Addendum No. 01

Date	October 1, 2026	Pages	4 (incl. 2 drawings)
To	All Bidders	From	Neil Caldwell, P.Eng PMP
Client No.		Jp2g No.	24-5090F
Project	St. Regis Police Station Site Upgrades	Contract:

MOHAWK COUNCIL OF AKWESASNE
ST. REGIS POLICE STATION SITE UPGRADES

ELECTRICAL
DETAILS, LEGENDS AND
DRAWING LIST

work with the Contractor. Costs for Telenet will be borne by the owner.

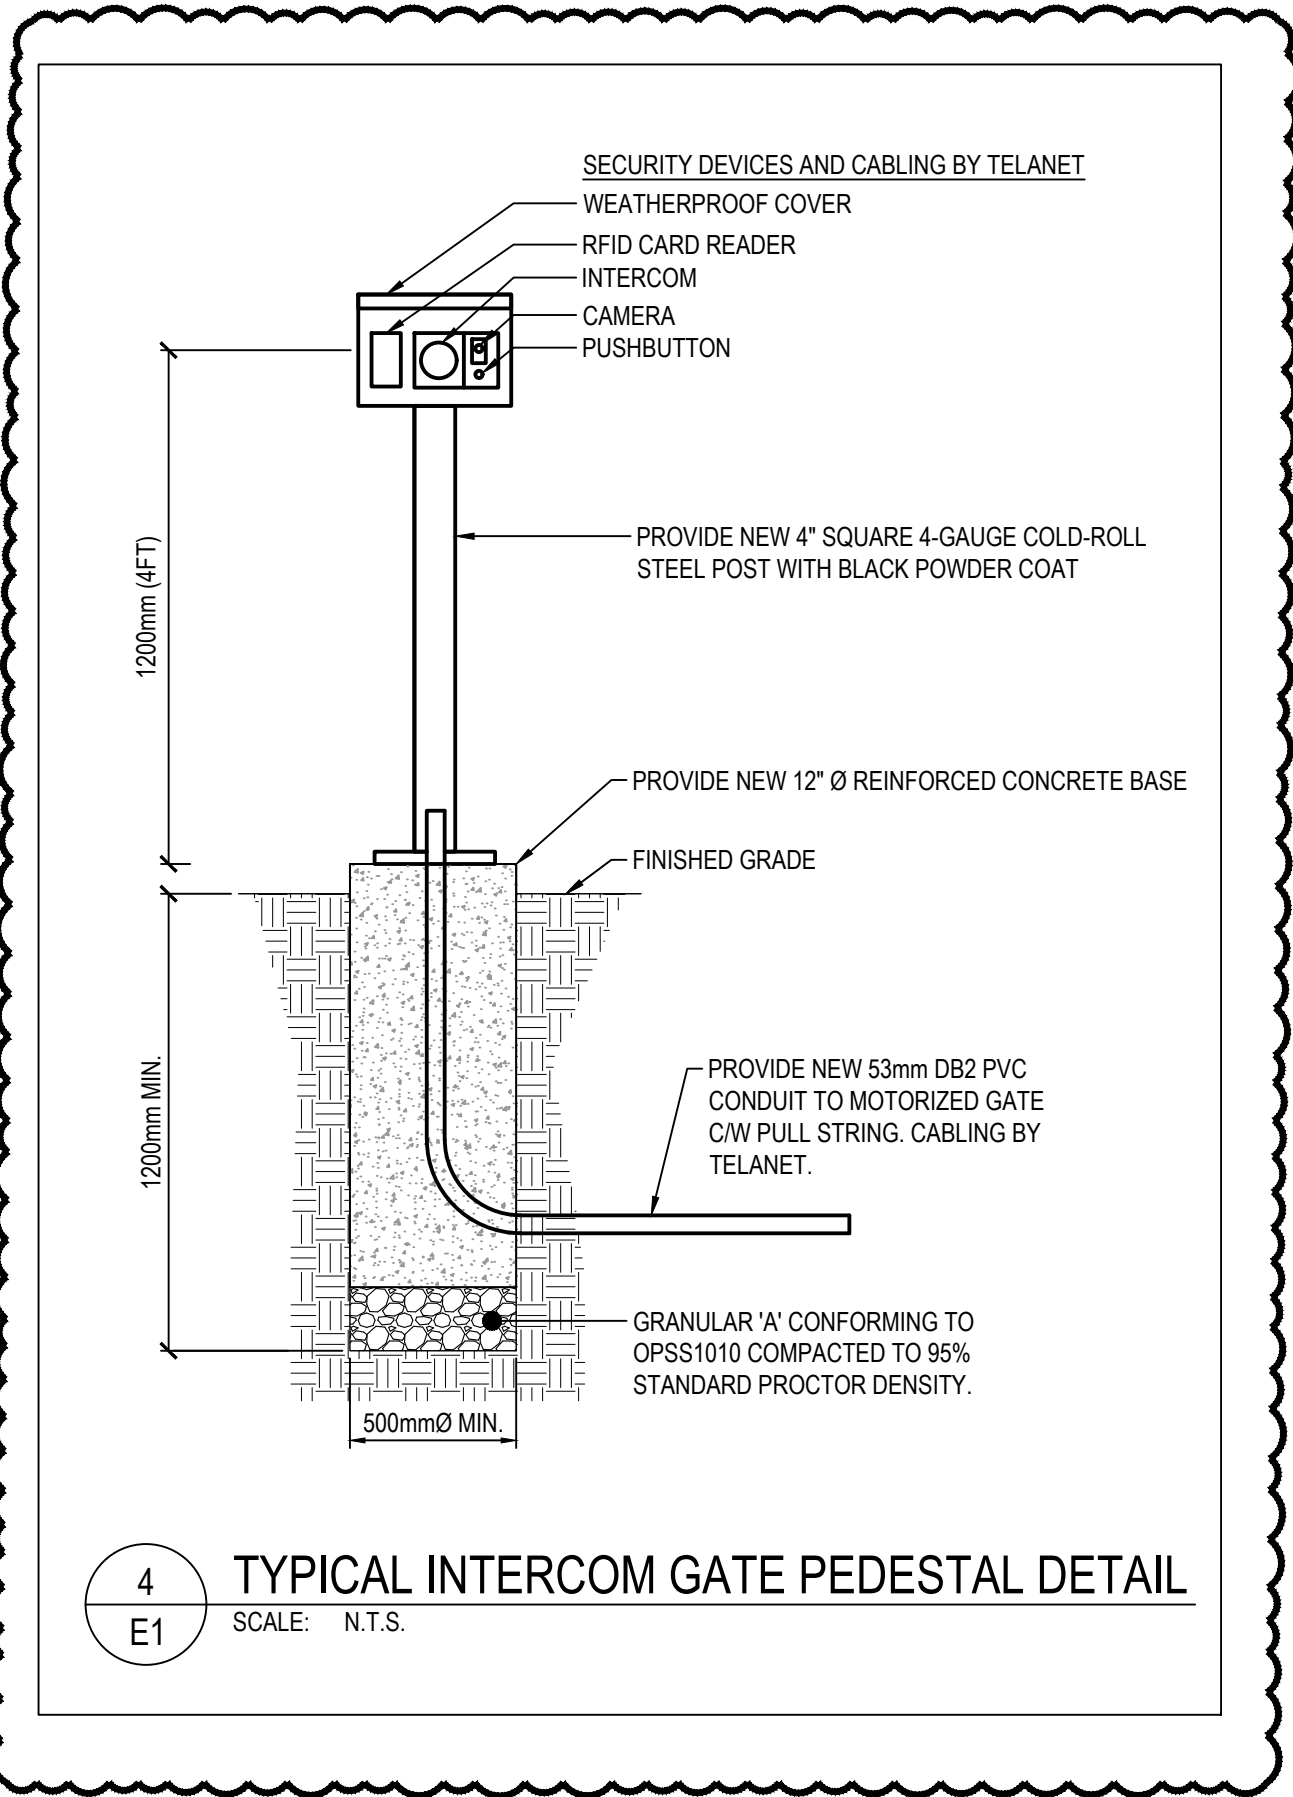
- i. Electrical **Drawings E1 and E2 are reissued for addendum #1 included with this addendum**, summary of changes include:

1. Reconfiguration and quantity of ducts.
2. Addition of camera pole and associated ducting.
3. Update location of electrical and communication tie ins in building.
4. Update to panel connections.
